ADDENDUM NO. 1

Sedgwick County Project: East 47th Street South and Oliver (R370)

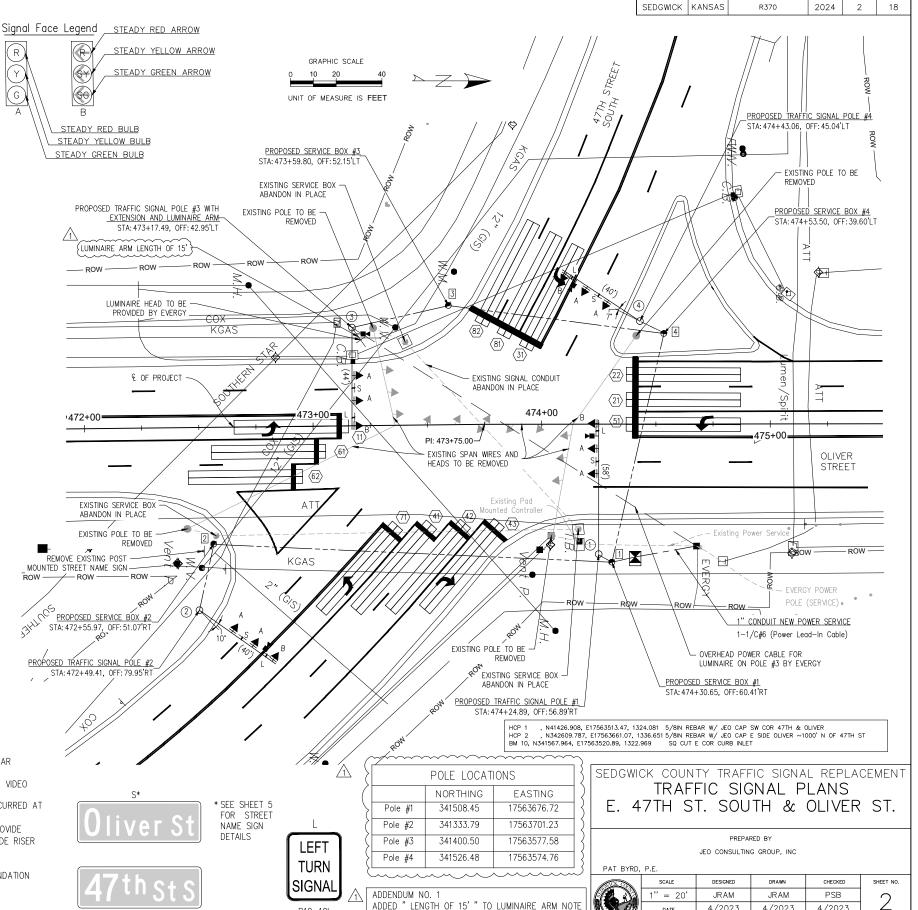
- Replace Sheet 2 with Sheet 2R. Specifies the length of luminaire arm and pole locations.
- Replace Sheet 9 with Sheet 9R. Revision to Wind Load on the Traffic Signal Pole.

MOVED POLE LOCATIONS TABLE UP
